Cadillac

SERVICEMAN SUPPLEMENT

No. 6 November 22, 1957

Fig. 1

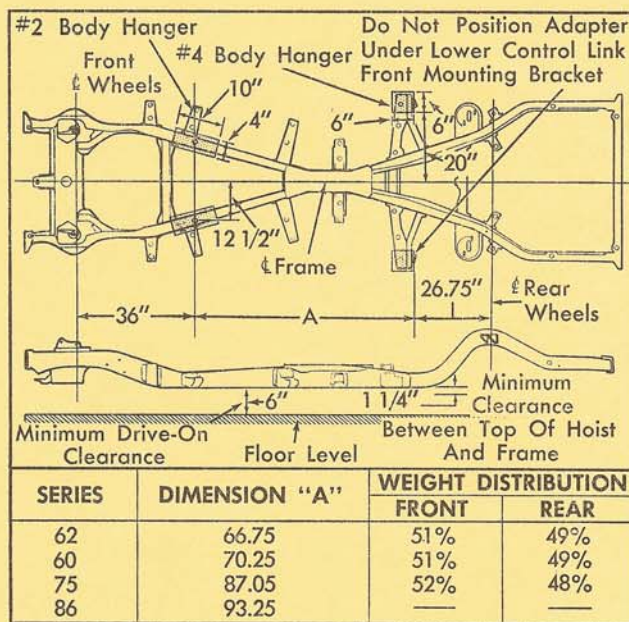
Fig. 4-7 in the Chassis Suspension Section of the 1958 Cadillac Shop Manual Supplement, and Fig. 3 in the November issue of the "Cadillac Serviceman", were published in error. Specifications for raising all 1958 Cadillac cars, except series 7059, on frame contact hoists are shown in Fig. 1 below. Written instructions remain the same as outlined in the Manual.

Only equipment that engages the suspension, axle or wheels should be used in lifting the series 75 and 86 cars. This equipment is the preferred type for lifting all Cadillac cars.
